BELL SYSTEM PRACTICES
Outside Plant Construction
and Maintenance

ADDENDUM G50.607.2
Issue 1, May, 1957
AT&TCo Standard

CABLE SPLICING—GENERAL

SOLID PIC CABLES

ARRANGEMENT OF UNITS
AHA (22 Ga), AKM (24 Ga) AND AKT (26 Ga) TYPES

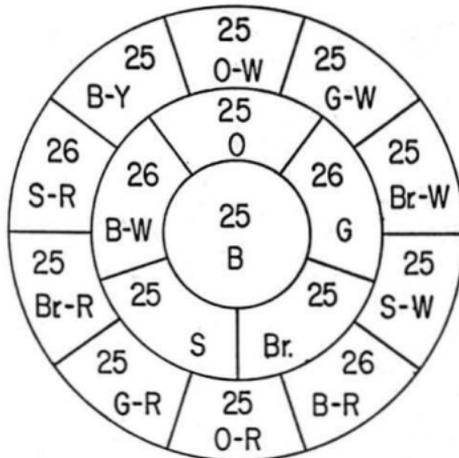
1.01 This addendum is issued to cover the core make-up of 404-pair (a new size) coded type, solid PIC cables of 22, 24, and 26-gauge.

2.01 The arrangement of the units and the color code of the binding strings are shown in the sketch on the following page.
